Addendum to a section 42A report for notices of requirement under section 168 of the Resource Management Act 1991 by Auckland Transport for new designations to enable the construction, operation and maintenance of transport corridors

Technical Specialist Memo Addendum

**Subject: Supporting Growth Alliance – Submissions on Warkworth NoRs 4, 5 and 7
Response to Evidence regarding Geotechnical Engineering and Earthworks**

Figure 10: Mapped distribution suspected large-scale active or inactive landslides identifiable from aerial photography

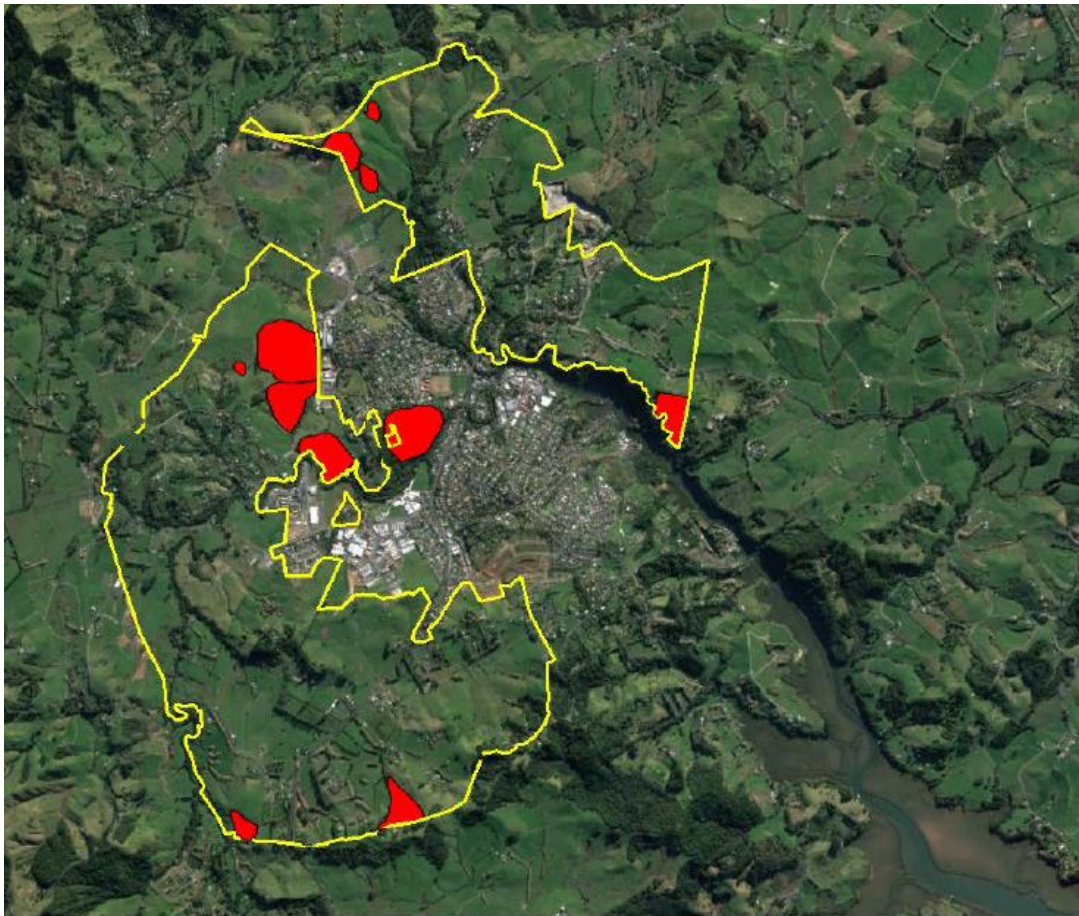
2.20 I also note that the map on Figure 10 of the Auckland Council Geotechnical and Coastal Hazards Topic Report – Warkworth Structure Plan (March 2018), shown below, indicates that there are no suspected large-scale active or inactive landslides within the area of the Sandspit Link route options.

2.21 Therefore, I consider that the SGA response given in Mr Paterson’s statement of evidence, with respect to a plan showing the natural hazards, is satisfactory - No further response from SGA is therefore required.
